Re: Council File 19-1077  
1140 S Broadway  
Response to Appeal ENV-2018-3289-CE-1A  
PLUM Committee Hearing Date: February 11, 2020 – Item No. 6

Subject: 1138–1140 Broadway Hotel – Response to Loeb & Loeb LLP Letter

CASE NO. ZA-2018-3288-CUB-SPR  
**LETTER OF SUBSTANTIAL CONFORMANCE**  
1140 South Broadway (1138-1142 South  
Broadway)  
Central City Planning Area  
Zone : C2-4D-O-SN  
C.D. : 14 – Huizar  
D.M. : 126A209  
CEQA : ENV-2018-3289-CE  
Legal Description: Lots 28 and 29, Tract 2289

Revised "A"  
**EXHIBIT "A"**  
Page No. 16.5.01.23  
Case No. ZA-2015-2258-CUB-SPR

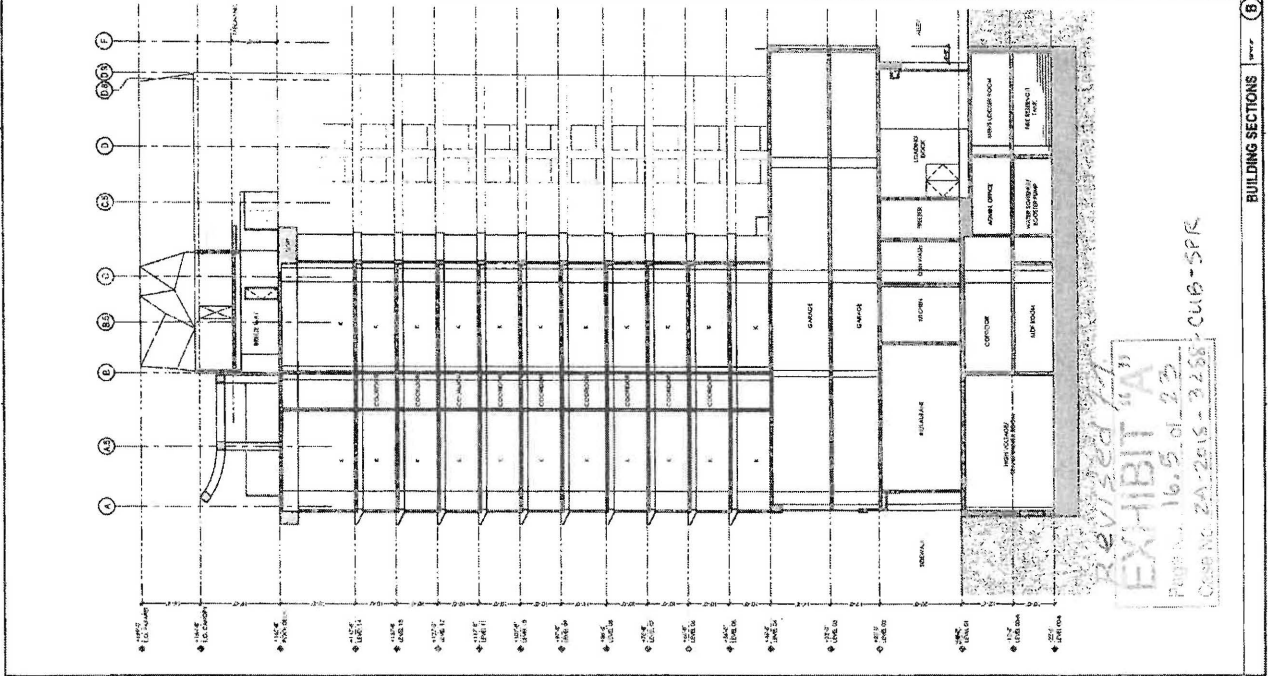
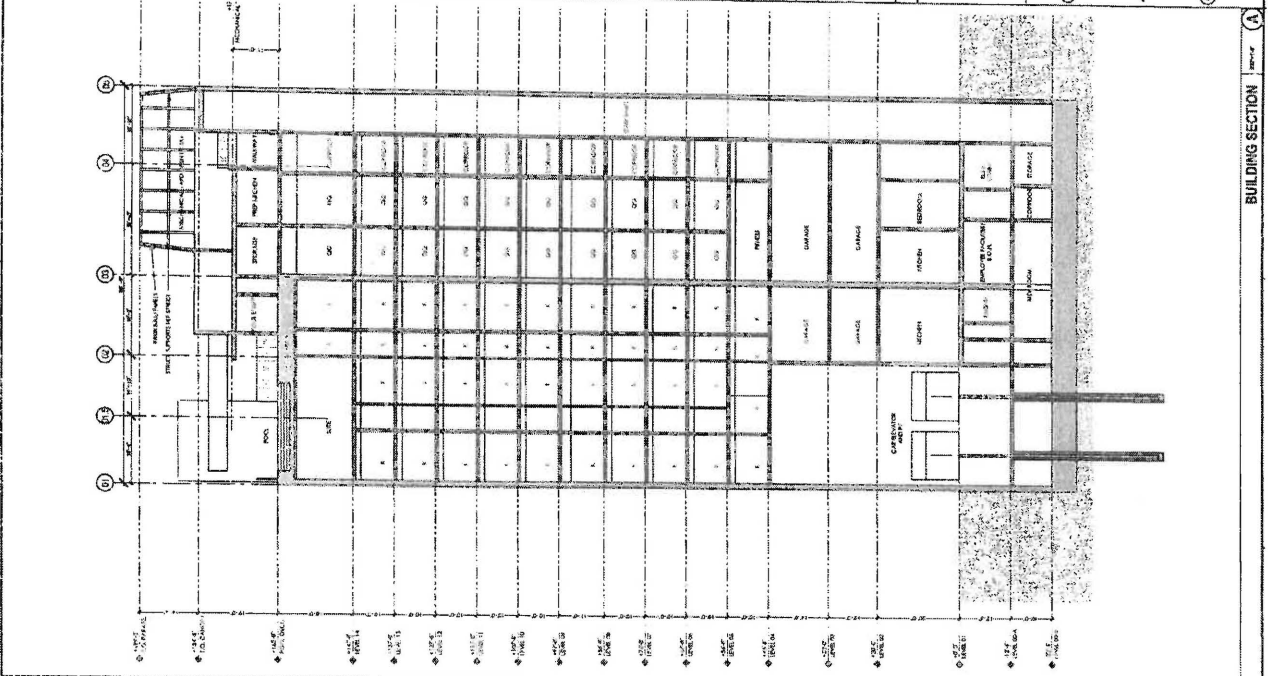
On December 20, 2019, the applicant submitted plans for plan check review with the Department of Building and Safety (PCIS No. 19010-10000-05938). The applicant made a slight revision to the ground floor plan by providing an approximately 4-foot wide setback along the ground floor of the rear property line adjoining the alley. The revised plans allow for better alley circulation and access. On February 3, 2020, the applicant filed a miscellaneous permit clearance application seeking clarification and confirmation that the

minor revision to the plans are still in substantial conformance to the previously approved set of plans stamped Exhibit 'A'. The applicant submitted updated floor plan (Sheet 7) and updated building sections (Sheet A3.1-1) depicting the rear yard setback.

A review of the revised plans show that the building envelope and height are essentially the same as the approved plans. While the ground floor will now provide a setback along the rear property line, the second through fourth levels remain unchanged and will cantilever over the ground floor setback to the property line consistent with the approved plans. The updated building section shows a 20' high clearance is provided from the ground to the second floor along the rear setback to accommodate adequate clearance for commercial vehicles within the alley. The location of the tower remains the same and all design elements and design features remain unchanged. No changes or modifications are requested to any of the conditions of the grant.

The Zoning Administrator finds that the revised plans remain in substantial conformance to the original approved plans stamped Exhibit 'A' and attached to the Zoning Administrator's May 23, 2019 determination (which consisted of 23 sheets). The attached floor plan stamped "Revised Exhibit A" and number Page 5.5 of 23 shall supersede and replace Page 5 of 23 of the original approved Exhibit 'A' and the attached building sections stamped "Revised Exhibit A" are hereby added as Page 16.5 of 23 of previously approved Exhibit A.
